APPLICATION FOR A CERTIFICATE OF APPROPRIATENESS – STAFF REPORT

079-18-CA 613 WILLS FOREST STREET
Applicant: DAVID COLE FOR INCLUSION STUDIO PLLC
Received: 6/12/2018 Meeting Date(s):
Submission date + 90 days: 9/10/2018 1) 6/28/2018 2) **8/23/2018**

Nature of Project: Addition of full 2nd story to existing 1 ½-story rear addition; roof alteration to rear of historic pyramidal roof

079-18-CA
Staff Evidence
1914 Sanborn Fire Insurance Map

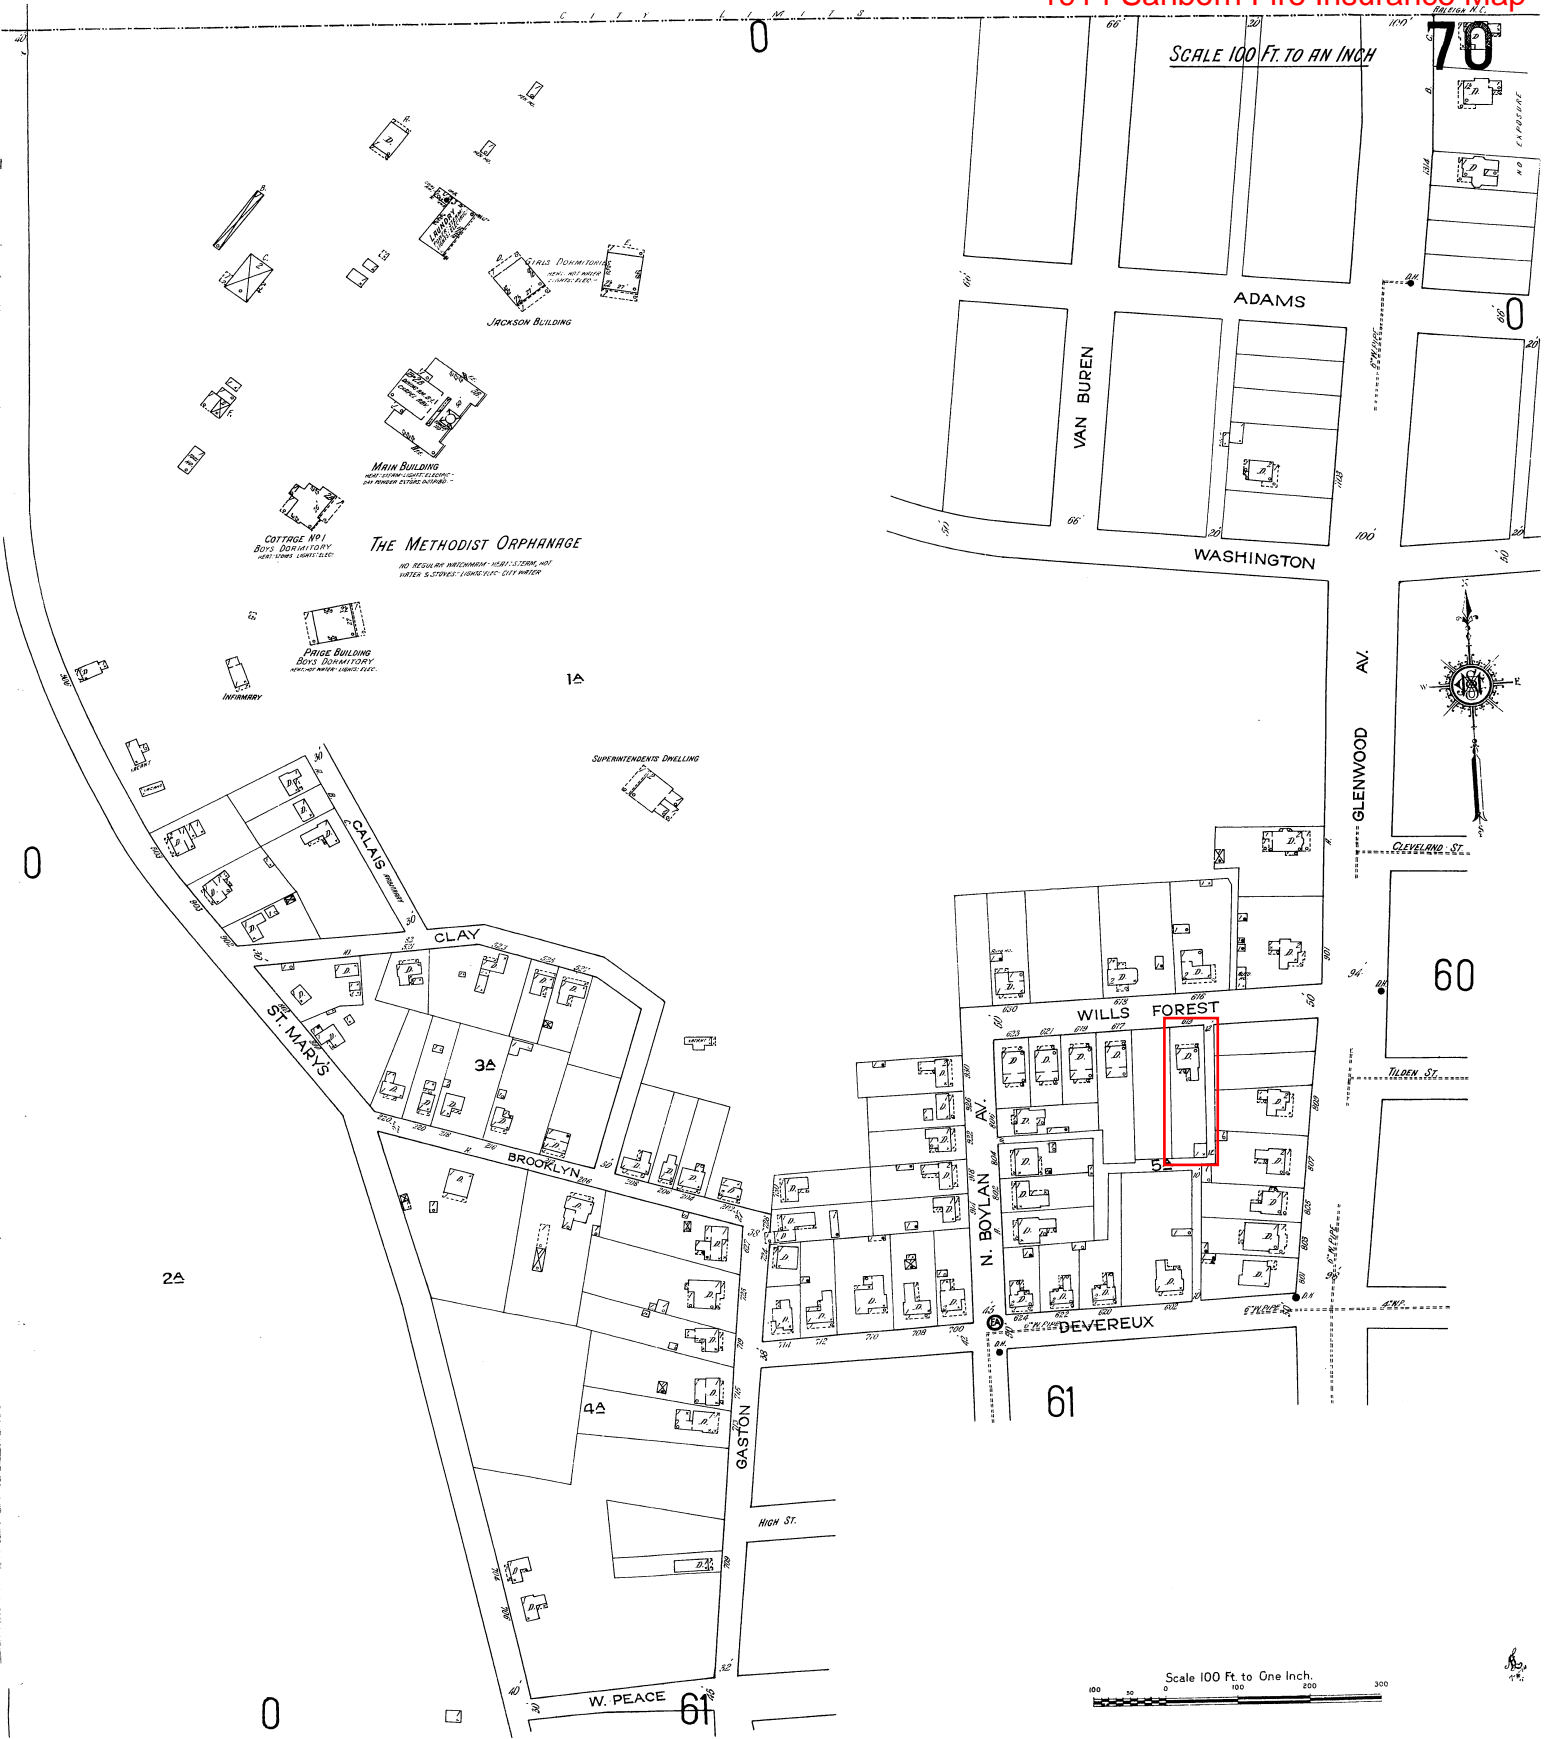
- 2* The Sanborn Fire Insurance Map from 1914 shows what appears to be a one-story addition on the rear of the house. The map is included as staff evidence.
